## AlgoRex EP7F-Z2.1

### Release Notes for Tool Coordinators

The document describes the differences between the AlgoRex release packages EP7F-Z1 and EP7F-Z2.1. It is intended for Tool Coordinators who need to know what is new and/or different in EP7F-Z2.1.

### Tab "Events"

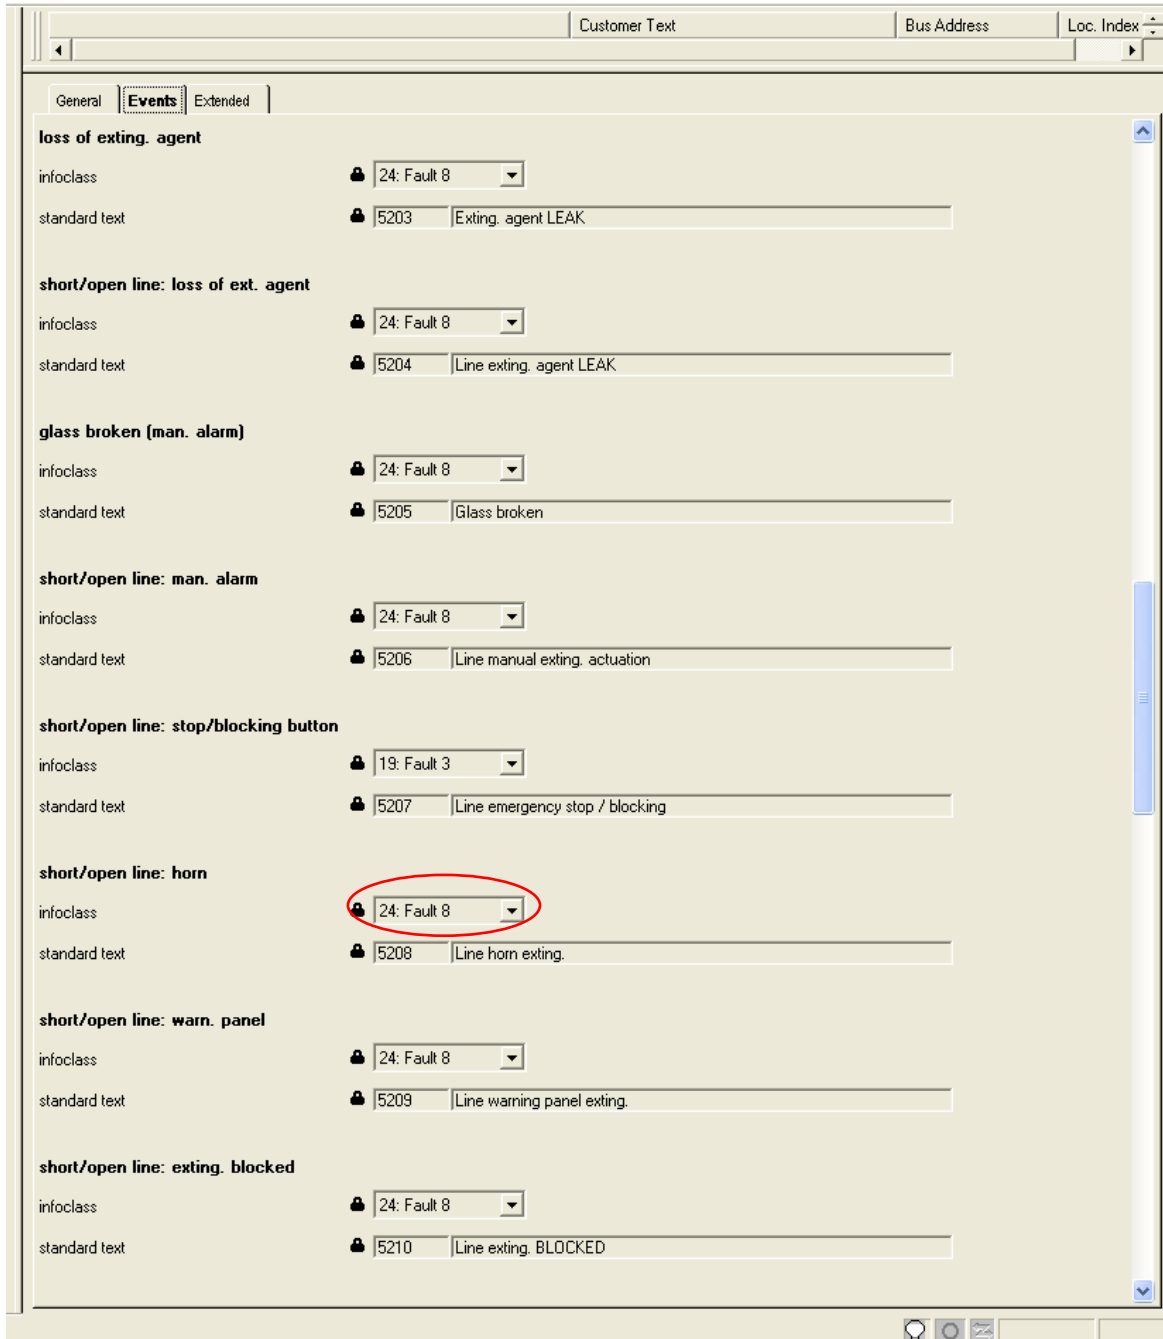
- Set all info points to **Fault8** (resetable)

## 7.6.8 New panel types

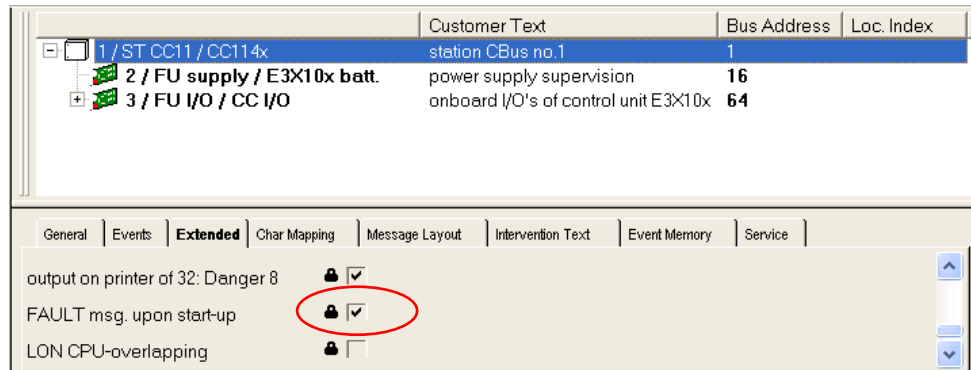
The new panel types B3Q661, B3Q681, B3Q686 (each with “progr.” & “exting.” subvariants) has been added. At the moment only B3Q661 is available.

The country defaults for Stations CI11 and CT11 are affected.

The following CT panel types have been set as default.

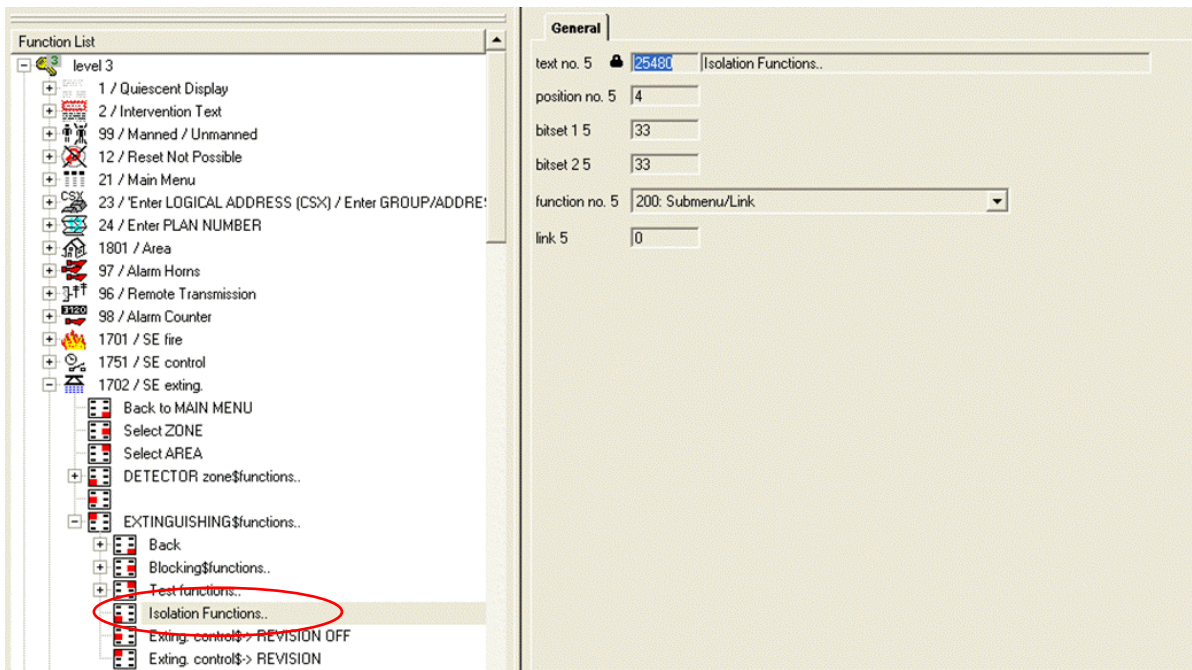
CI1142/43:        **B3Q660/80** progr.  
 CI1145 :         B3Q460/80 progr. (no change)  
 CT1142/43:       **B3Q660/80** progr

If you like to change the default panel type, please use the function *Replace*.
